Product Change Notice (PCN)

Subject: Assembly factory change for Shunt Regulator power supply IC

Publication Date: 2/13/2023

3p PoMM: Changed outline drawing. No change in dimensions (partial change in notation method)

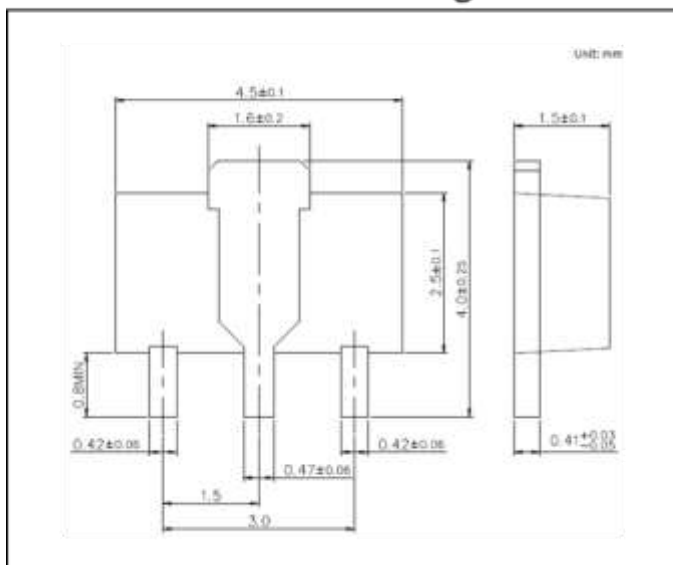
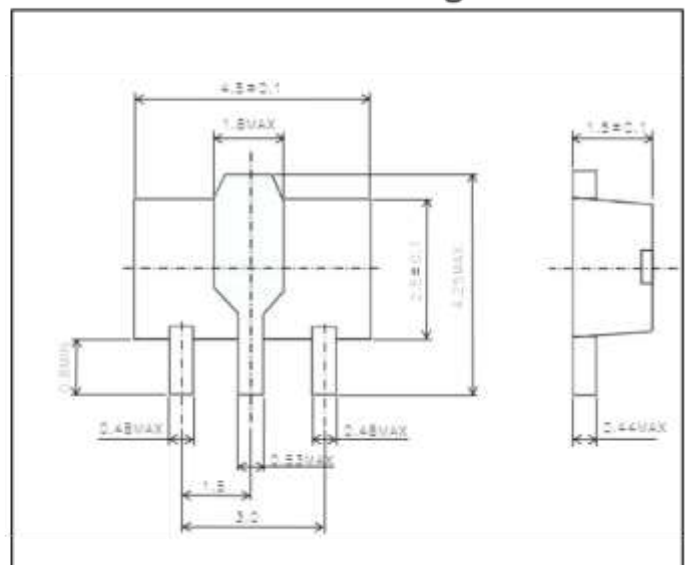
Before the changes

After the changes

5p MM: Changed outline drawing. Some dimensions have changed (some notation methods have changed)

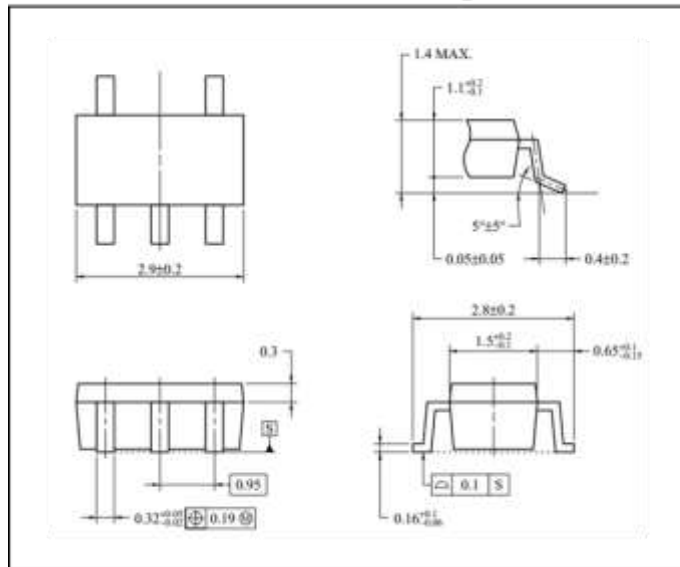
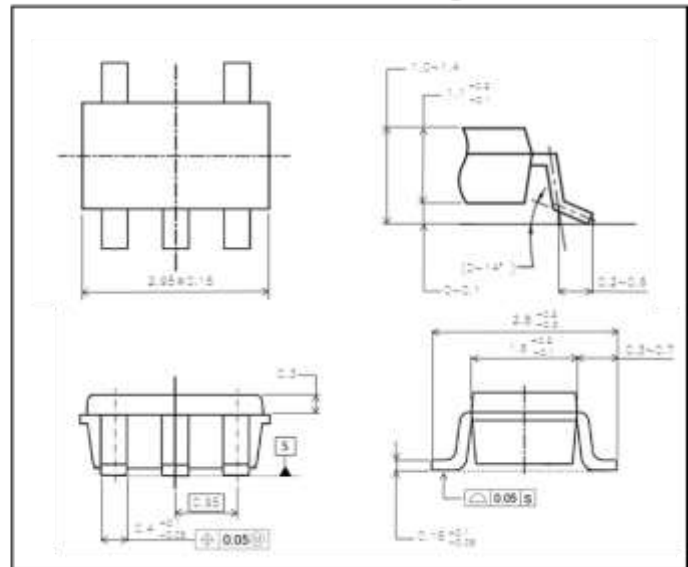
Before the changes

After the changes

< 3p PoMM >

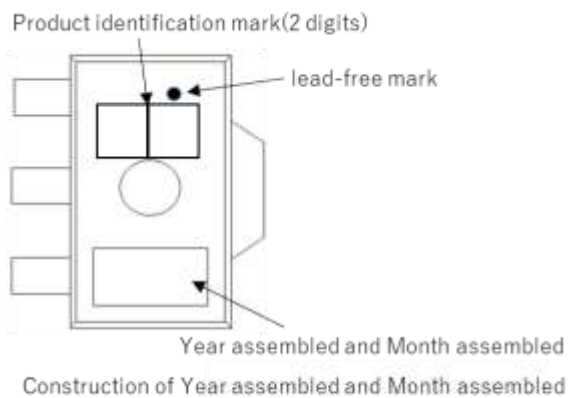
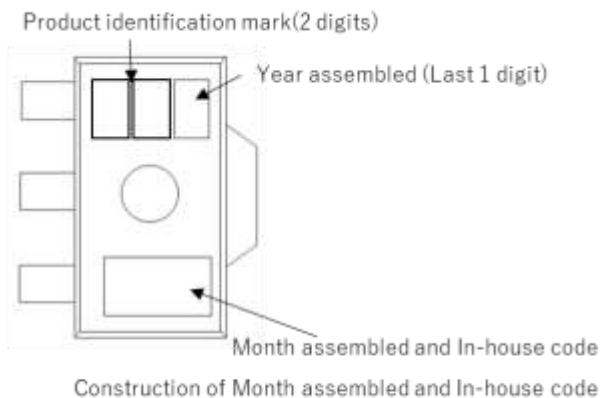
Before the changes

Construction of Year assembled and Month assembled

After the changes

Construction of Month assembled and In-house code

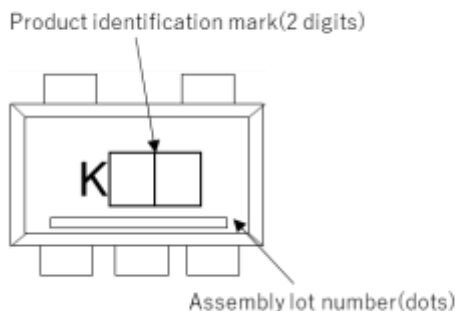
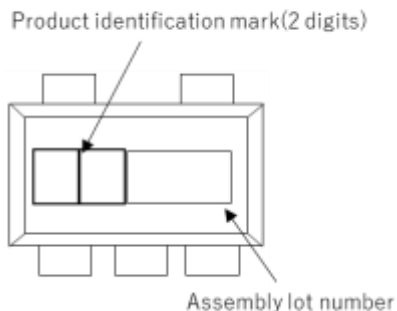
Before the changes

Construction of lot number

After the changes

Construction of lot number
